***MODIFICATION REQUEST:
Wollongong Hospital Redevelopment
Crown Street, Wollongong
MP 10_0213 MOD 3***

***Modifications to the internal layout and façade
treatment of the multi-level car park and
associated landscaping***

Secretary's
Environmental Assessment Report
Section 75W of the
Environmental Planning and Assessment Act 1979

February 2015

Figure 4: Proposed Level 5 layout

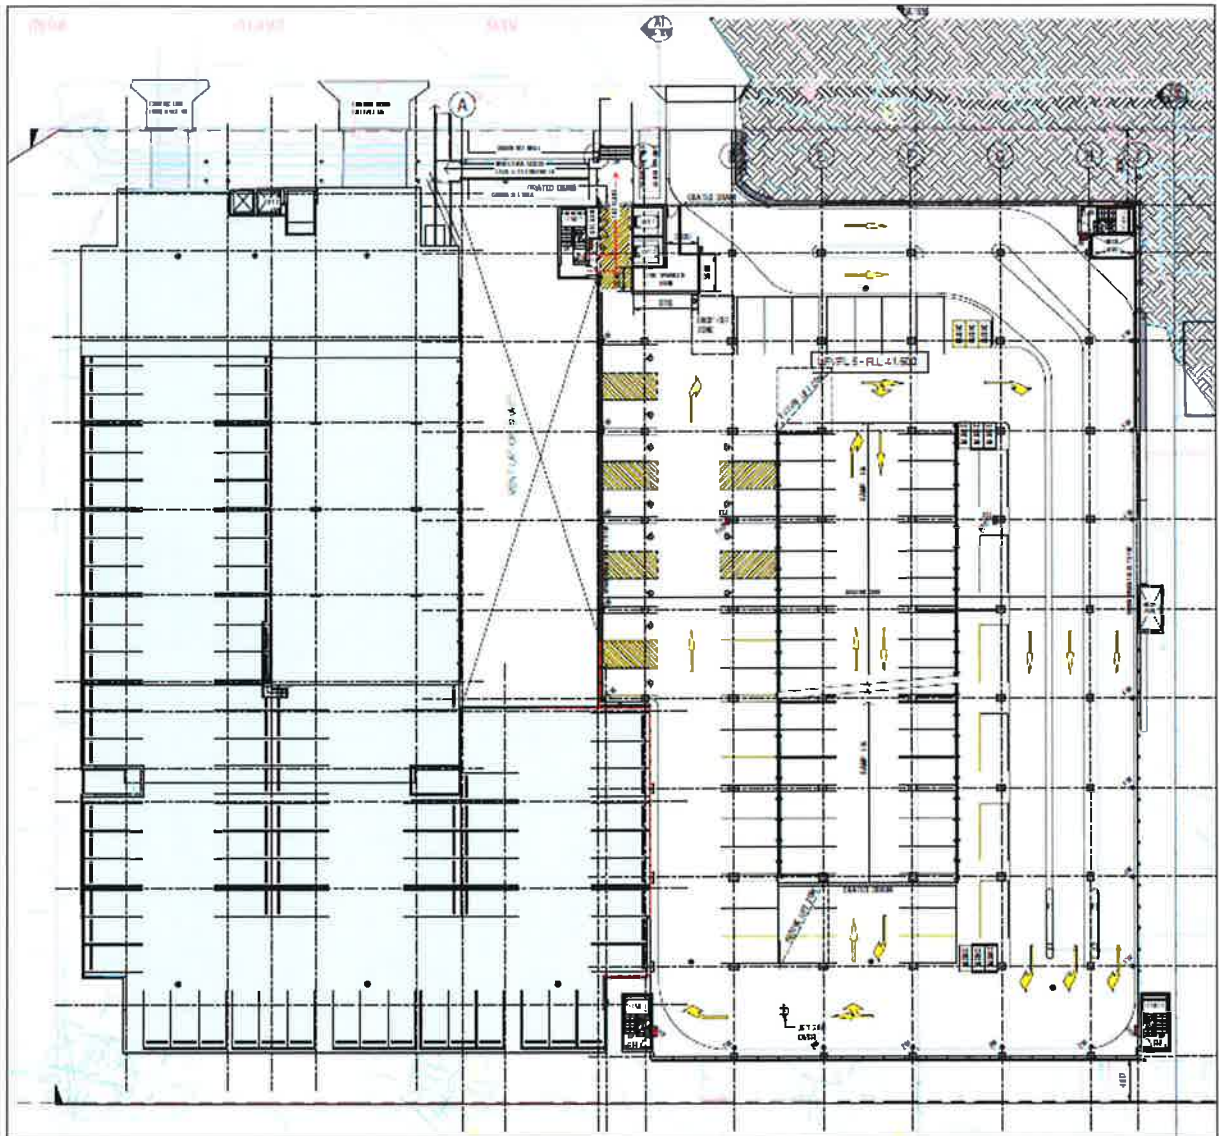
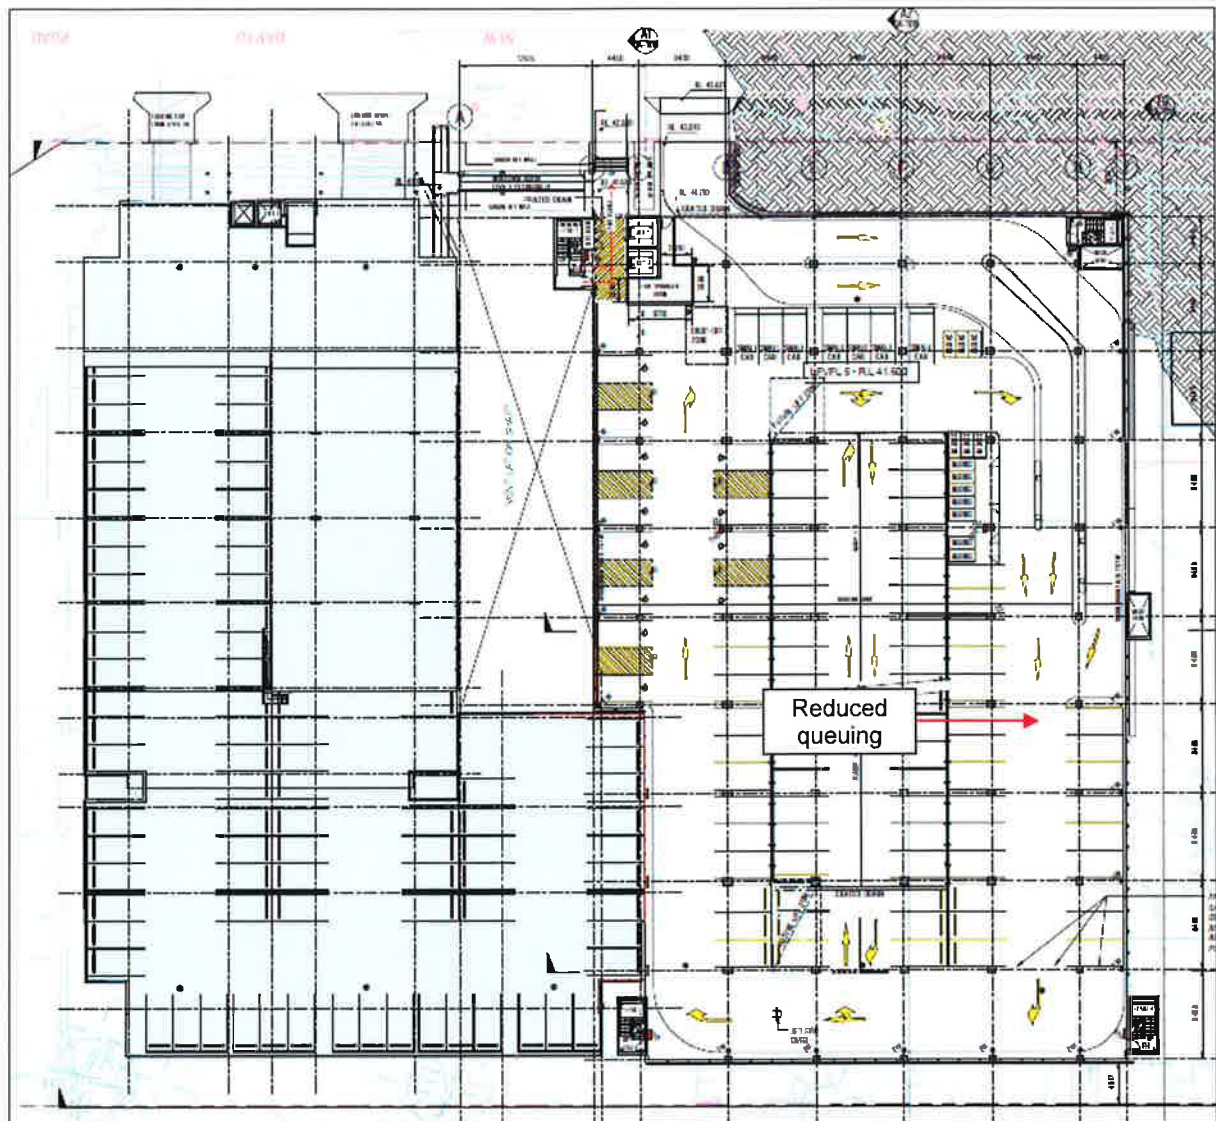
The main vehicle entry to the new car park is from New Dapto Road on Level 5. The main entry is controlled by boom gate access and supported by two lanes, which extend the length of the car park, to allow vehicle queuing of up to 33 vehicles at the New Dapto Road entry (see **Figure 3** for approved Level 5 layout).

The proposed modification seeks to reduce the length of the lanes and reduce queuing space to 20 vehicles at the New Dapto Road entry. The reduced capacity for queuing at the boom gates has the potential to result in traffic impacts along New Dapto Road as vehicles could spill out onto New Dapto Road and impede traffic if adequate queuing space is not provided within the car park (see **Figure 4** for proposed amended Level 5 layout).

The Traffic Impact Assessment prepared by Cardno in support of the original modification application for the car park adopted the minimum queue lengths recommended in the Australian Standards, which is to be utilised in the absence of specific guidance regarding anticipated queuing. The current modification request is accompanied by a *Wollongong Hospital Queuing Study – Traffic and Transport Technical Note* (Queuing Study), also prepared by Cardno, which has undertaken an analysis of the likely queuing resulting from the potential peak vehicle entry levels and boom gate capacity.

The Queuing Study adopts the same assumptions used in the Traffic Impact Assessment regarding distribution of vehicles entering by New Dapto Road (75 per cent) and Dudley Street (25 per cent), as well as methodology used to determine peak traffic flows for the car park (740 vehicles per hour based on the new car park having 754 spaces). Therefore, there would be 555 vehicles entering the car park in the peak period via the New Dapto Road entrance.

The lane capacity for the access controlled car park would be between 600 vehicles per lane per hour (free flow) to 250 vehicles per lane per hour if manually controlled. As the boom gate access would be controlled by card reader (for staff) and automatic ticket issue (for patients and visitors), the capacity would be between 300 and 400 vehicles per lane per hour. The lane capacity was further refined based on anticipated ratio of staff to visitors (73 per cent / 27 per cent) and resulted in a capacity of 373 vehicles per lane per hour.

The Queuing Study concludes that based on the approach volumes and lane capacity a total queue length of 120 metres (20 vehicles) is required for two lanes to support the 95th percentile queue length (i.e. the length of queue that has a probability of five percent or less of being exceeded during the peak access period). The proposed modification seeks to amend the plans accordingly to reduce queuing space on Level 5 (New Dapto Road access controlled entrance) to a total of 20 vehicles for the two lanes. The assessment is based on free flow of traffic after the boom gates, which could potentially be impeded by use of the car spaces immediately after the boom gates and the lane merges. The Queuing Study does identify various operational management measures that could be implemented should this scenario eventuate, including time restrictions on the car spaces, physical barriers during peak periods or allocation of the spaces to non-peak travelling staff or visitors. These could be implemented post construction if issues were to arise. Furthermore, if automatic number plate recognition technology is installed, the queuing space required for the New Dapto Road entrance would reduce to eight vehicles. Consequently, the proponent seeks to revise the layout of Level 5 to reduce the queue lengths and subsequently provide additional car spaces to further reduce demand on on-street car parking.

The proposed modifications are acceptable to the Department as the proponent has demonstrated that the queue lengths would generally be adequate for queues up to the 95th percentile queue length and RMS raised no objections to the methodology used to calculate the probable queue lengths or assumptions regarding peak traffic flow calculations. The Department also accepts that, as the additional car spaces are supporting existing car parking demand associated with the hospital, this traffic already exists on the road network and whilst it would be diverted to the car park, it would have comparable impacts on traffic efficiency. The Department has recommended a condition requiring monitoring of the car park queues during peak periods and a requirement to revise the car parking management plan if queuing issues arise.
